**From:** Mike Miller  
**Sent:** Thursday, December 5, 2024 2:07 PM  
**To:** Wendy Farley-Campbell  
**Cc:** Jacob Foutz; kurth.clare@gmail.com  
**Subject:** RE: Butterclam/Siuslaw Bay View Utility Plan  
**Attachments:** As-built water system on Hwy 126.pdf; 23-022\_Leturno\_UtilityPlan\_11-13-2024 - PW Markups.pdf

# SITE PLAN WITH PROPOSED UTILITY PLAN FOR LETURNO-HWY 126

**From:** Michael Schick <chief@wlfea.org>  
**Sent:** Thursday, November 21, 2024 5:35 PM  
**To:** Jacob Foutz  
**Subject:** RE: Referral Request: PC 24 01 CUP 01 - Residential Development of 10 Units in a Commercial Zone

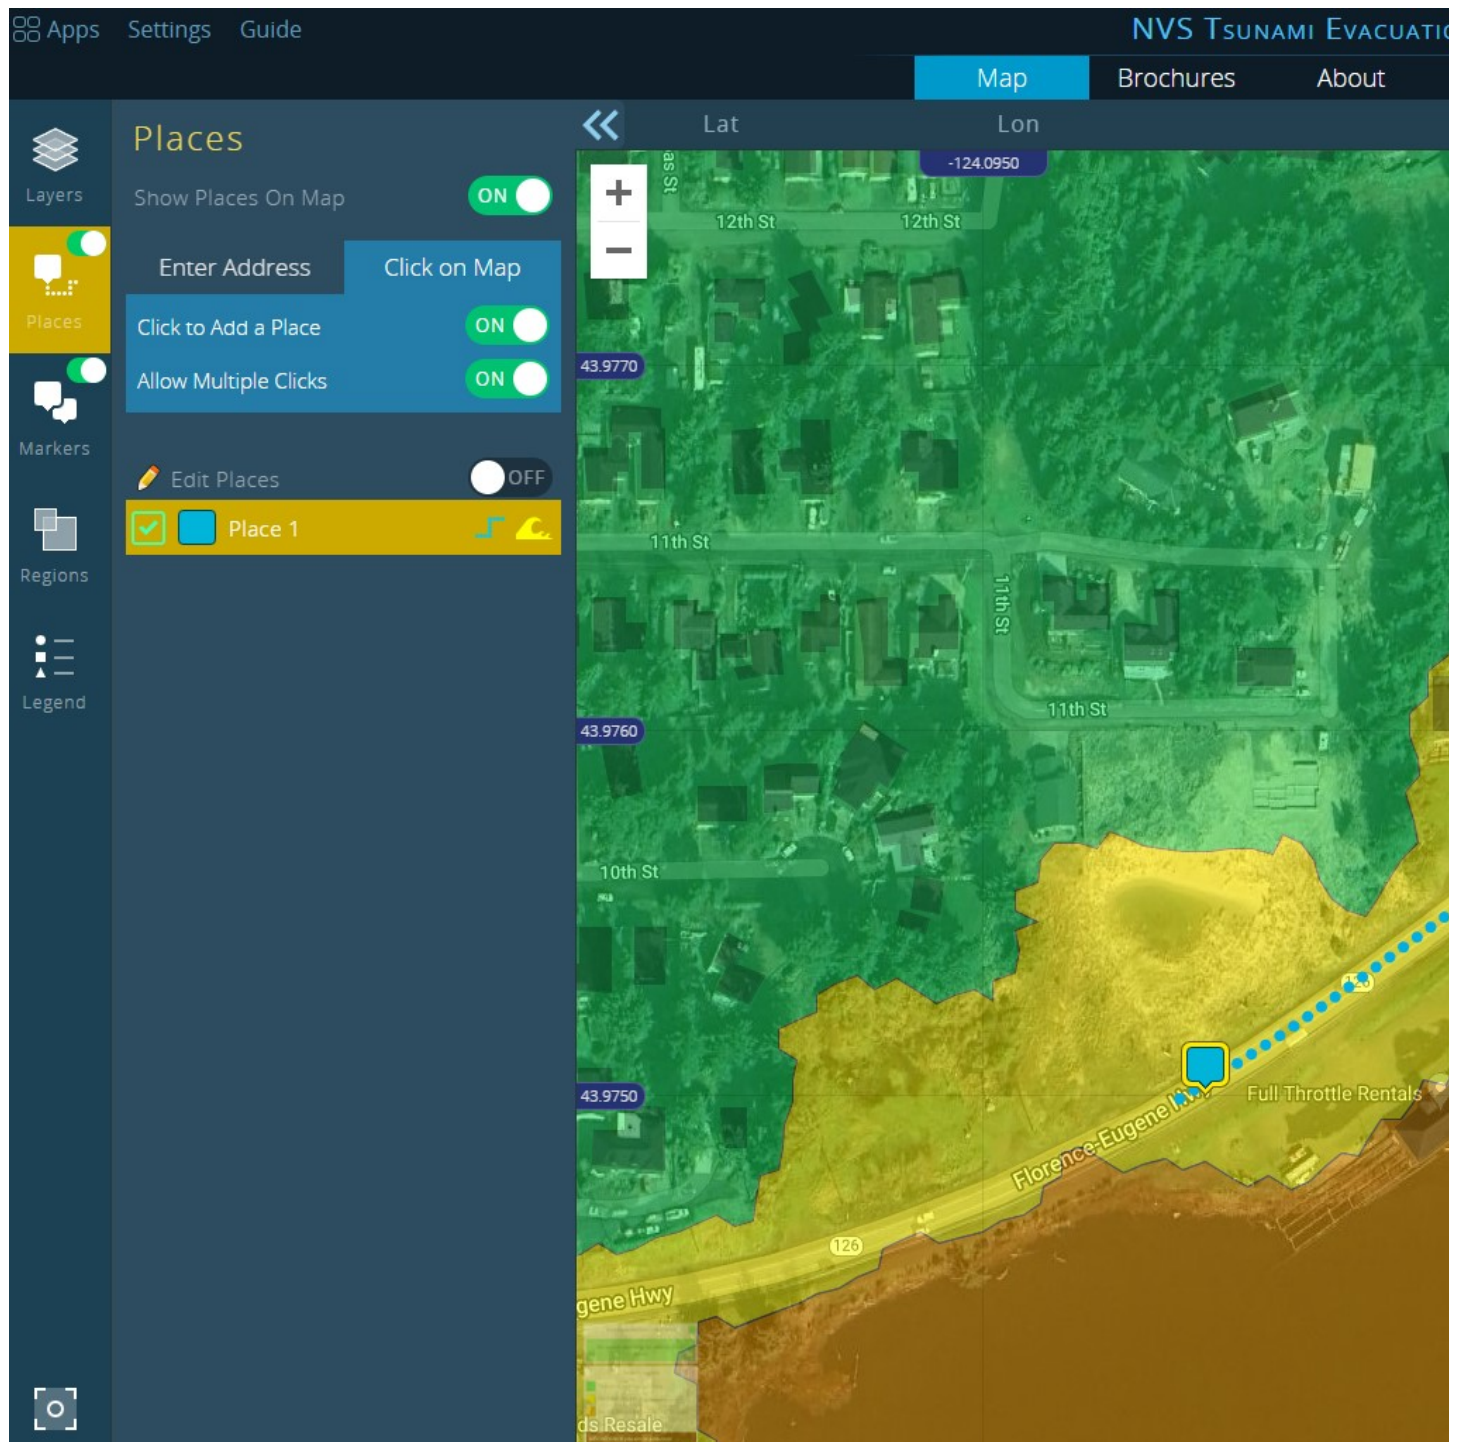
Thank you for considering tsunami hazards in your analysis of this site! A Cascadia tsunami is expected to reach this location about 40 minutes after the start of earthquake shaking. Safety can easily be reached before the tsunami's arrival via Highway 126; however, I expect liquefaction and lateral spreading along the river's edge to severely compromise passage along sections of this road. A detailed geotechnical study would be necessary to more fully examine the location and severity of these coseismic hazards (phenomena that occur during an earthquake in addition to ground shaking).

Because this route relies on a road that is likely to be significantly damaged as well as the fact that it requires evacuees to initially travel in the direction of the oncoming tsunami, I strongly encourage the site to develop a more direct evacuation route to the north. A footpath leading from the site to high ground in the direction of 11<sup>th</sup> St would only need to be ~100-200 feet long and would provide evacuees with a more direct and much shorter route to safety that avoids the river entirely.

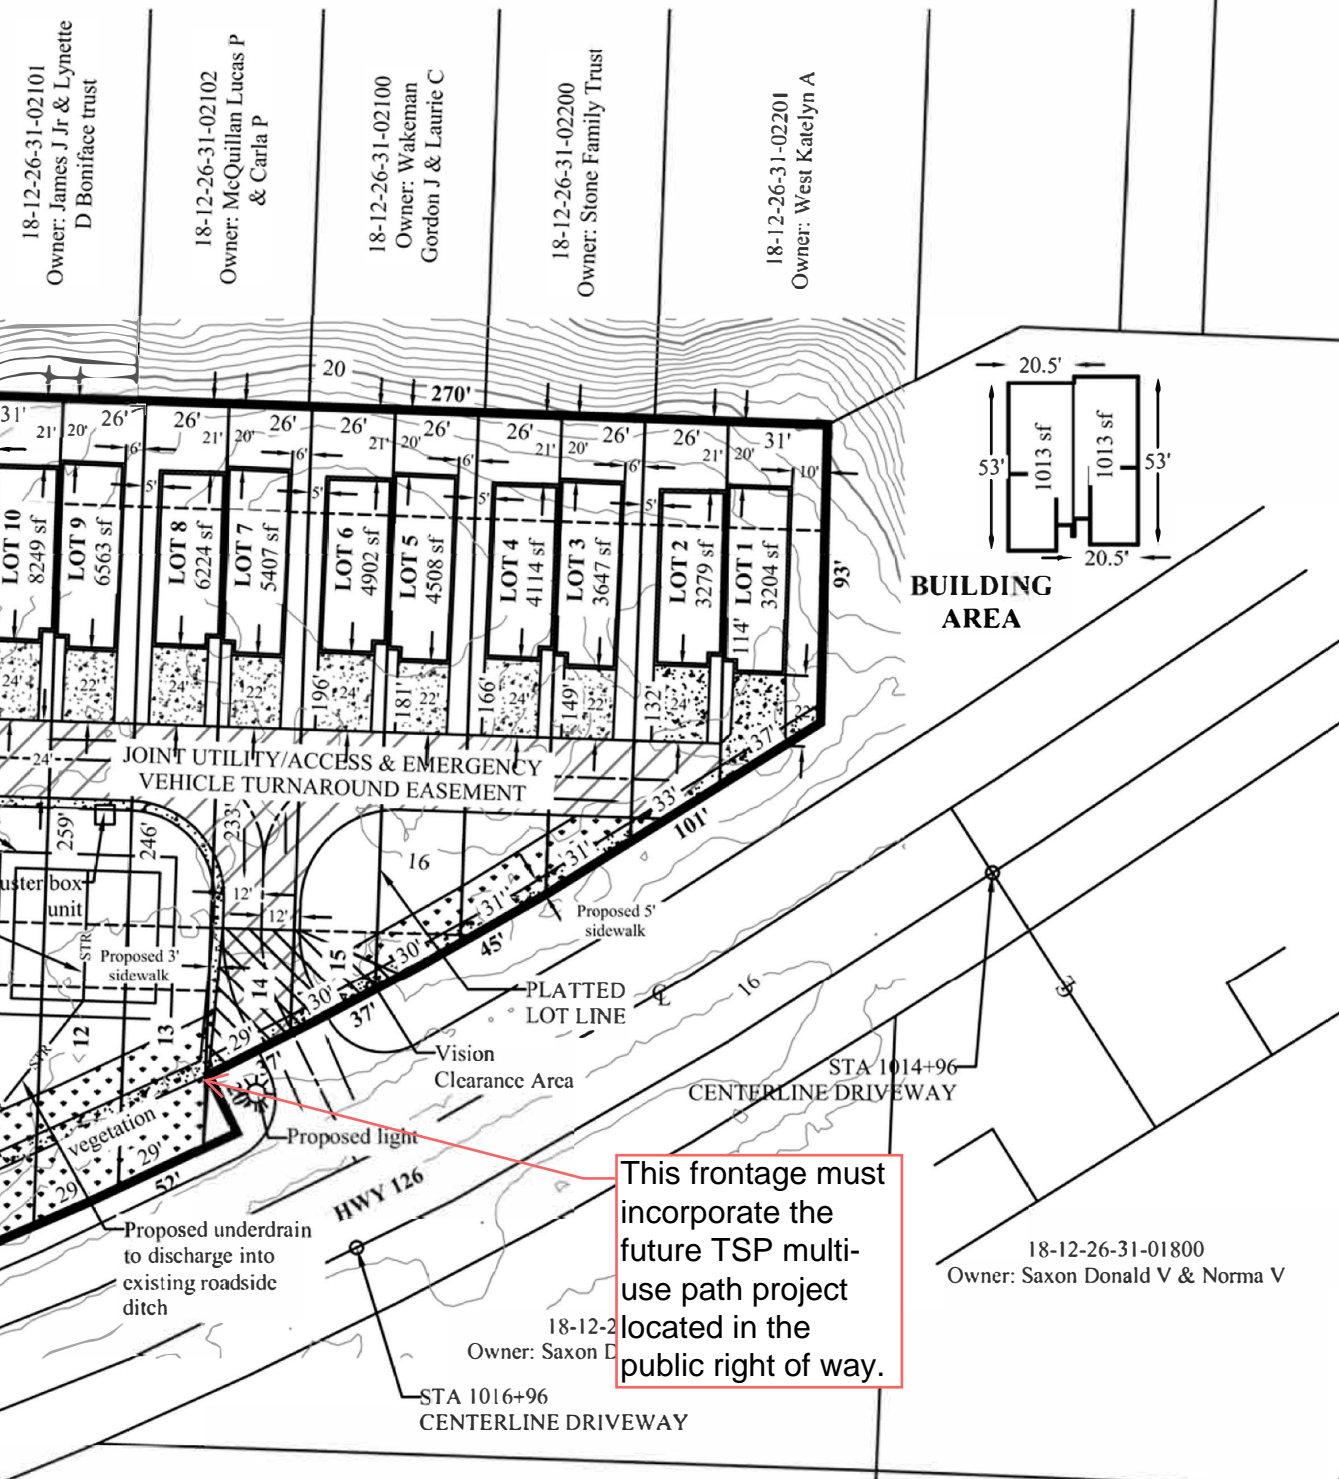
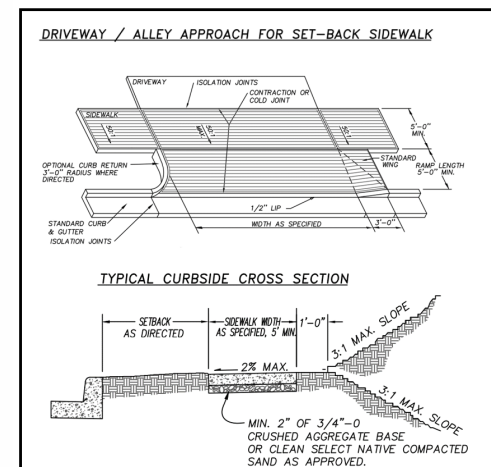
First thank you for sharing the drawing. The proposed utility layout is not what we have discussed for the project with the developer. Additionally, the existing City water system is not represented on the revised utility plan. Attached is the as-built drawing that shows the 12-inch water main being extended to the east near the property line of the development.

The revised utility plan is confusing and it is unclear what the intent is of the water system at the east end of the development. Are they proposing to connect and loop the lines?

As stated during our conversations with the developer, since they are maintaining the lots and lot lines out to Hwy 126, and not showing any fire hydrants in the interior private street, they can install individual water services and meters at the property line at Hwy 126, so there is no need to extend an 8-inch water main into the private street/easement. The existing 2-inch water service towards the west side of the project will need to be removed at the developer's expense.

The sanitary sewer needs to be extended to and through the project. This will require the installation of a sanitary sewer manhole within the ROW of Hwy 126 at the east side of the development. The manhole needs to have an invert elevation that will allow for the future extension of the sewer system to the east. The invert elevation out of the manhole needs to be 6.02 feet.

Stormwater system will require a design report in order to verify that the facility is sized and designed appropriately.

**Proposed sanitary sewer infrastructure not shown in plan and profile format with connection to existing utility and specific COF elevation requirements for future development to east**  
**Proposed Water system improvements not shown with connections to existing utility**  
**Proposed storm sewer plan requires more detail including a profile plan showing proposed slopes**  
**All construction plans shall include detail sheets with all pertinent COF Standard Drawings for construction**

This frontage must incorporate the future TSP multi-use path project located in the public right of way.

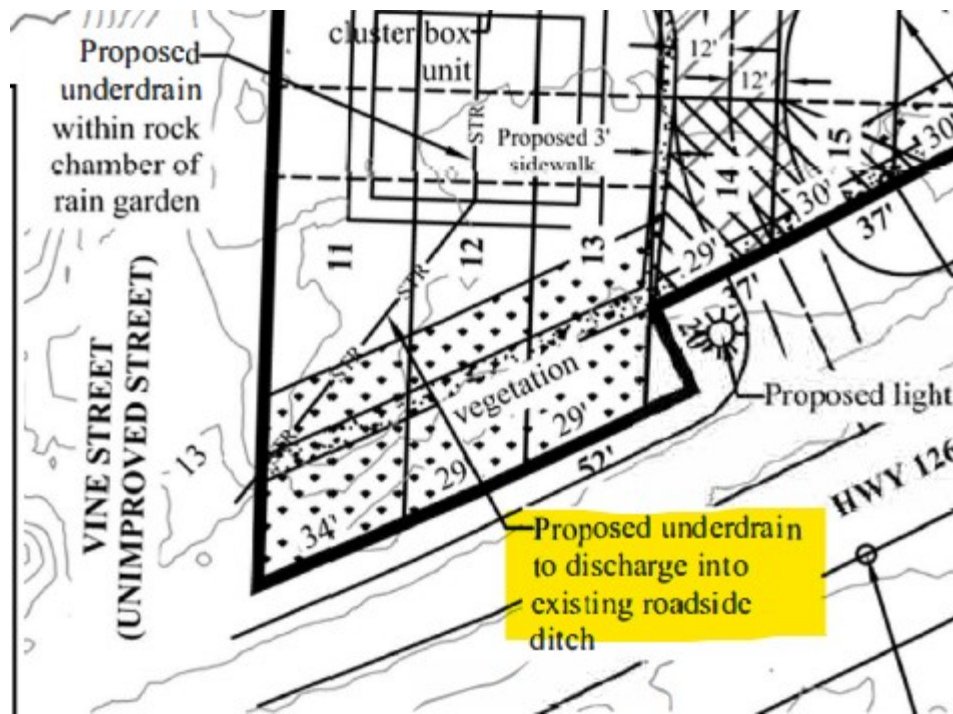
- 1) Please let me know what comments ODOT has for the stormwater plan attached. Below are two snips from the plan on where they are proposing the discharge.
  - City Code doesn't permit the stormwater discharge into ROWs, but ODOT comments would be great too since Hwy 101 is an ODOT facility

- 2) They are asking for a non-remonstrance for the sidewalks on the Hwy 126 street frontage. What are ODOTS thoughts on this request?
  - City Code provides a path for this request with residential zoning, but not residential uses. So, City Code doesn't support this.
  - However, if there is a plan for street improvements or realignments then that would offer a path for a non-remonstrance.
  - Also, please note, the sidewalks are proposed on private property. Does ODOT have a preference on whether this will require an easement or a dedication?
- 3) Below is a snip from the 2023 TSP discussing a project for a walking and bike connection along Hwy 126.
  - What expectations does ODOT have for the applicant on this project?
  - Is there adequate space for this project, or will the pathway affect their proposed site plans

ODOT can support the new approach proposal for this development. I do have some draft input into the frontage improvement plans for this development. I am still awaiting input from our District 5 Maintenance Office as to their support for the sidewalk and light pole. Who would maintain the light pole and new sidewalk? Would the City be ok with a separated sidewalk such that a curb would not be necessary? I am still waiting for more input from our maintenance District but so far our Roadway reviewer has shared that if a light pole is proposed within the ODOT right of way fronting this property than it must be up to ODOT standards for breakaway design for light poles within the clear zone. ODOT does not have the authority to require sidewalk from developments, but sidewalk could be placed within ODOT right of way behind ditch with transitions back to highway shoulder as has been done recently with developments on the north end of Florence on US101. If the sidewalk is intended for public use but located on private property, then ODOT recommends a minimum 6' wide sidewalk in a public easement if it is on private property (6' minimum width this is a requirement if it is placed within ODOT right of way). If the sidewalk were placed on private property and for site use only then ODOT would have no comments regarding the sidewalk. A stormwater report detailing the tested infiltration rates, ground water elevations and expected discharge rates into our R/W will be required.
